SUBJECT: ISSUANCE OF AMENDMENT (TAC NO. 75870)

JAMES A. FITZPATRICK NUCLEAR POWER PLANT

Amendment No. 158
License No. DPR-59

SAFETY EVALUATION BY THE OFFICE OF NUCLEAR REACTOR REGULATION
RELATED TO AMENDMENT NO. 158 TO FACILITY OPERATING LICENSE NO. DPR-59

Figure 3.6-1 Part 1 Reactor Vessel Pressure-Temperature Limits Through 12 EFPY

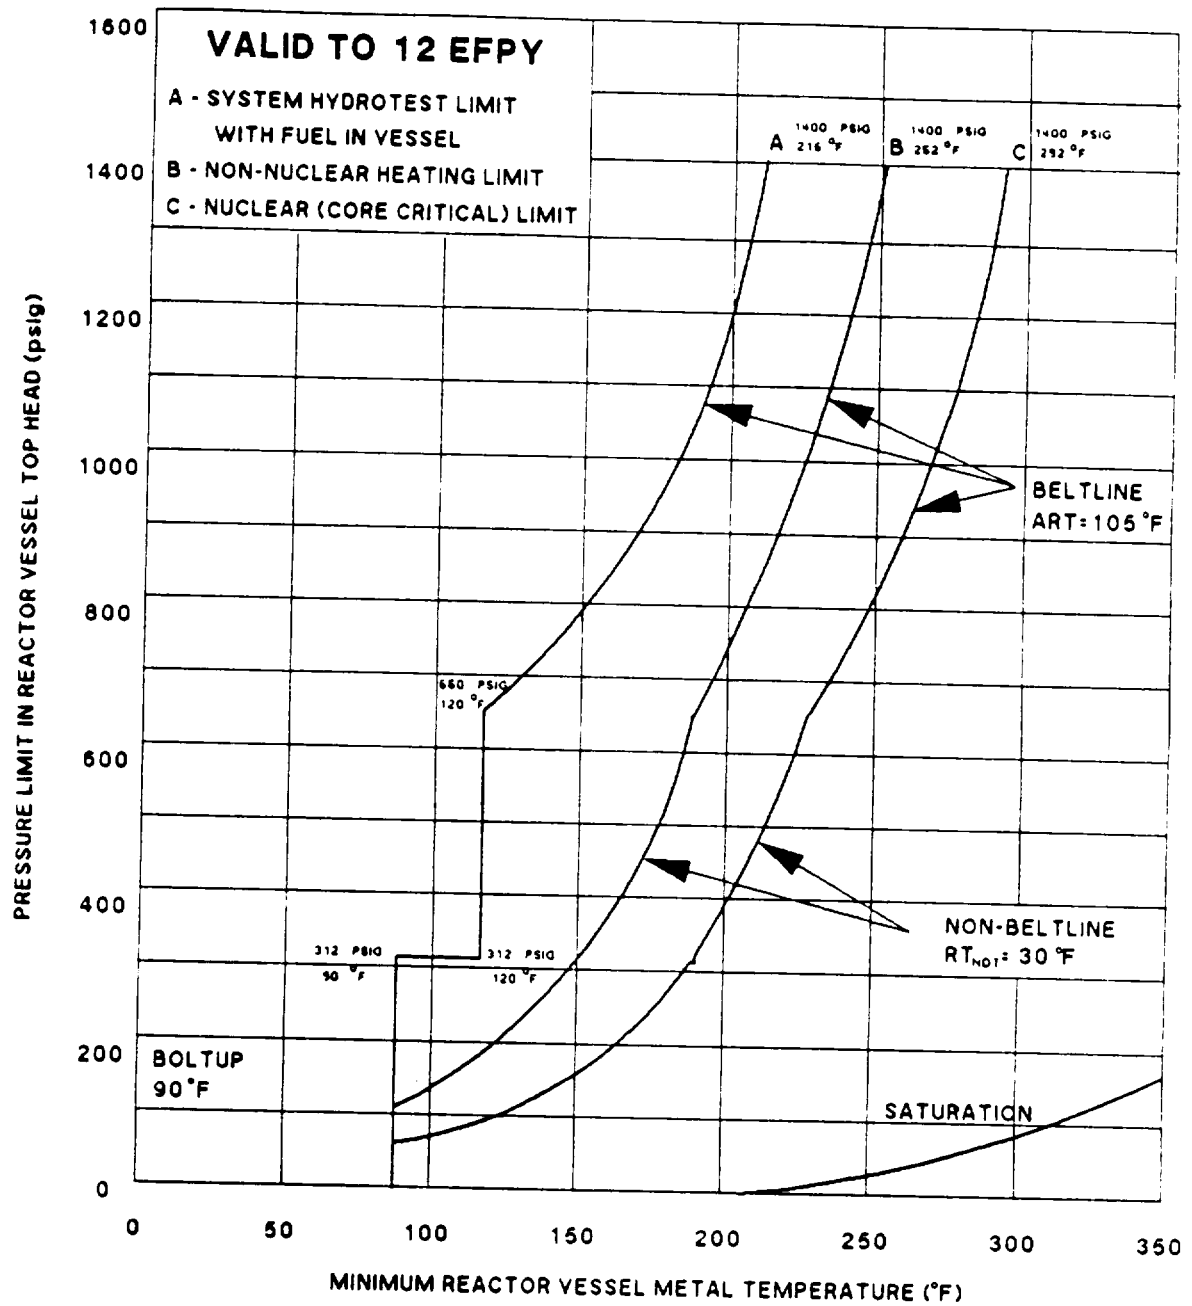
The amendment replaces the existing Reactor Vessel Pressure-Temperature Limit curves with new curves for operation to 12, 14 and 16 effective full power years and revises the corresponding Limiting Condition for Operation and Bases section to reflect the new pressure-temperature limits.

Figure 3.6-1 is comprised of three parts: Part 1, Part 2, and Part 3. Parts 1, 2, and 3 establish the pressure-temperature limits for plant operations through 12, 14, and 16 Effective Full Power Years (EFPY) respectively. The appropriate figure and the pressure-temperature curves are dependent on the number of accumulated EFPY. Figure 3.6-1, Part 1 is for operation through 12 EFPY, Figure 3.6-1, Part 2 is for operation at greater than 12 EFPY through 14 EFPY, and Figure 3.6-1, Part 3 is for operation at greater than 14 EFPY through 16 EFPY. The curves contained in Figure 3.6-1 are developed from the General Electric Report DRF 137-0010, "Implementation of Regulatory Guide 1.99, Revision 2 for the James A. FitzPatrick Nuclear Power Plant," dated June, 1989.

During in-service hydrostatic or leak testing the Reactor Coolant System pressure and temperature shall be on or to the right of curve A shown in Figure 3.6-1 Part 1, 2, or 3 and the maximum temperature change during any one hour period shall be:

During heatup by non-nuclear means (mechanical), cooldown following nuclear shutdown and low power physics tests the Reactor Coolant System pressure and temperature shall be on or to the right of the curve B shown in Figure 3.6-1 Part 1, 2, or 3 and the maximum temperature change during any one hour shall be $\leq 100^{\circ}\text{F}$.

During all modes of operation with a critical core (except for low power physics tests) the reactor Coolant System pressure and temperature shall be at or to the right of the curve C shown in Figure 3.6-1 Part 1, 2, or 3 and the maximum temperature change during any one hour shall be $\leq 100^{\circ}\text{F}$.
